Addendum 128– UN Regulation No. 129

Revision 4 – Amendment 1

Supplement 1 to the 03 series of amendments – Date of entry into force: 28 May 2019

Uniform provisions concerning the approval of Enhanced Child Restraint Systems used on board of motor vehicles (ECRS)

Figure B
Pictogram according to ISO 2575:2004 - Z.01 that shall be used and that shall have an
outer diameter of at least 38 mm

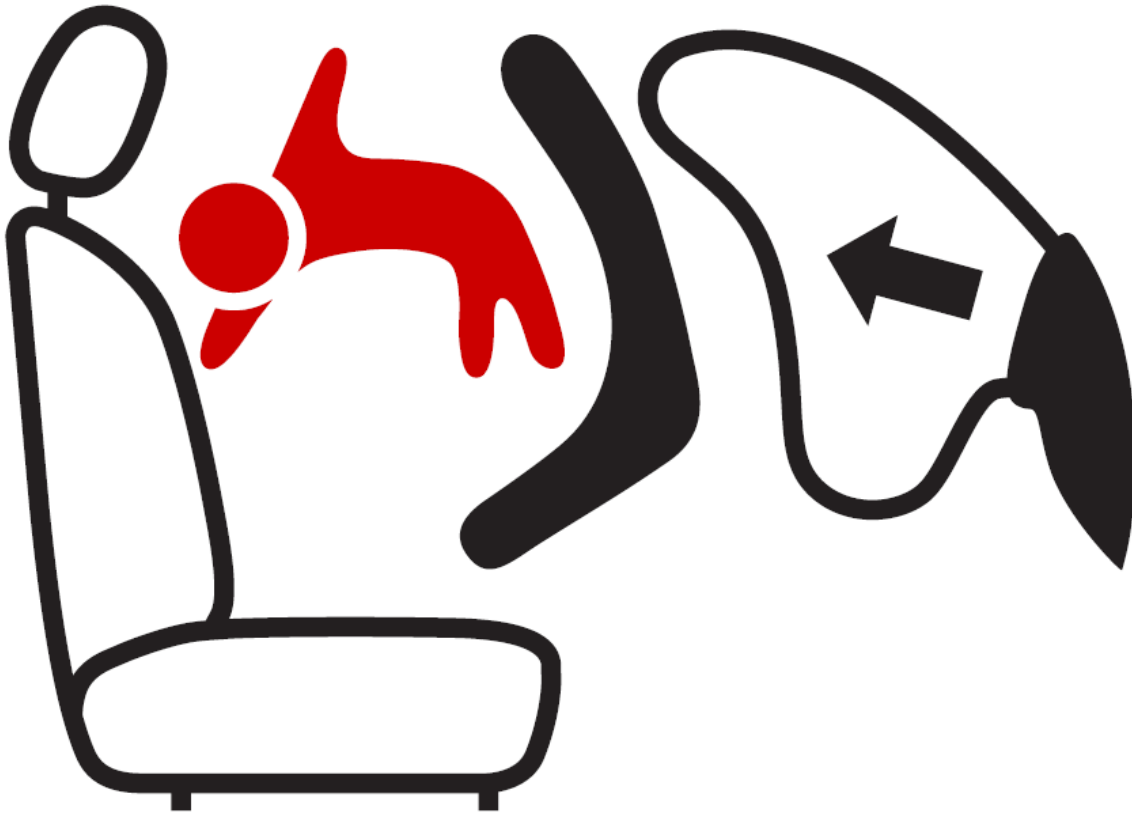
Paragraph 4.4., amend to read:

"4.4. On the visible inner surface (including the inside surface of a side wing beside the child's head) in the approximate area where the child's head rests within the child restraint system, rearward facing restraints shall have the shown label permanently attached.

The overall dimensions of the label shall be at least 120 x 60 mm or the equivalent area.

The label may be adapted in such a way that the layout differs from the example shown here; however, the content shall meet the precise prescriptions. Furthermore, no other type of information shall be included on the label unless it is placed outside a clearly marked rectangle with at least the overall dimensions as required above. In derogation to the aforementioned, a part number, bar code or similar identification mark not exceeding 8 mm x 35 mm or the equivalent area may be placed on the label.

It shall also be ensured that no deviations in the shape and orientation of the provided pictograms are permitted, notably that any customised appearance of the prescribed pictogram images shall be prohibited, with the exception of the hand with pointing index finger and the open face booklet with letter 'i' on its right page provided that they are clearly recognisable as such.

Small irregularities concerning line thickness, label imprinting and other relevant production tolerances shall be accepted.
